WOKINGHAM
BOROUGH COUNCIL

Full Planning Approval Consultation

Application Number: 252934

Proposal: Full application for the proposed erection of 3 no. detached dwellings with associated access, parking and landscaping and creation of a balancing pond.

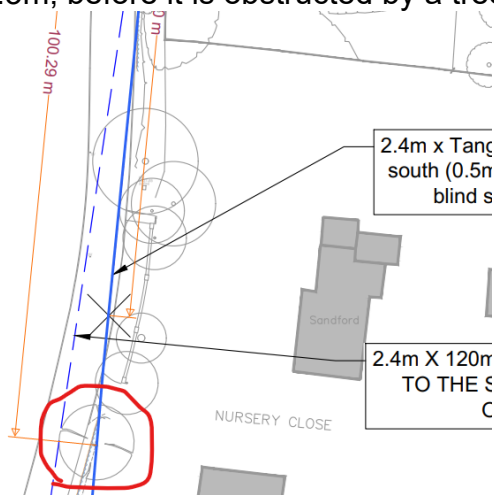
It is noted that the maximum SSD can be achieved along the tangent to the bend is circa 100.3m, before it is obstructed by a tree beyond applicant's control:

Given the speed limits changes from national speed limit to 40mph along the B3030 45m to the south of Sawpit Road, the applicant will be expected to achieve a minimum SSD of 102m for 40mph. The applicant shall consider relocating the proposed access circa 2m to the north to achieve the required visibility.
